5. COA-077183-2020

3101-3105 East Marshall Street

Commission of Architectural Review

STAFF REPORT

Figure 1. 3105 East Marshall Street, ca. 1957

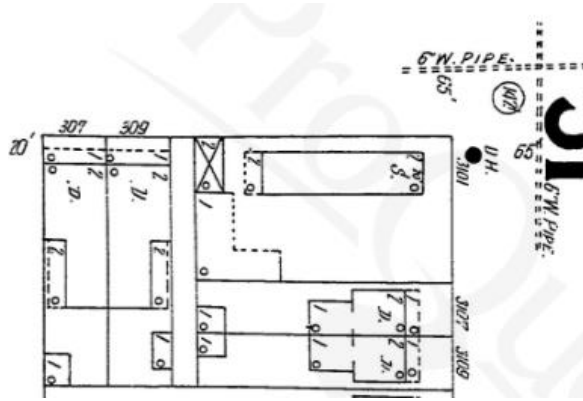
- the design of the rehabilitated historic storefront match the historic photograph including, but not limited to, the wood panels below the windows and the pilasters separating the bays; and the windows surrounding the door be a consistent size. Staff recommends the plans be revised to reflect this design prior to submitting the plans for the special use permit
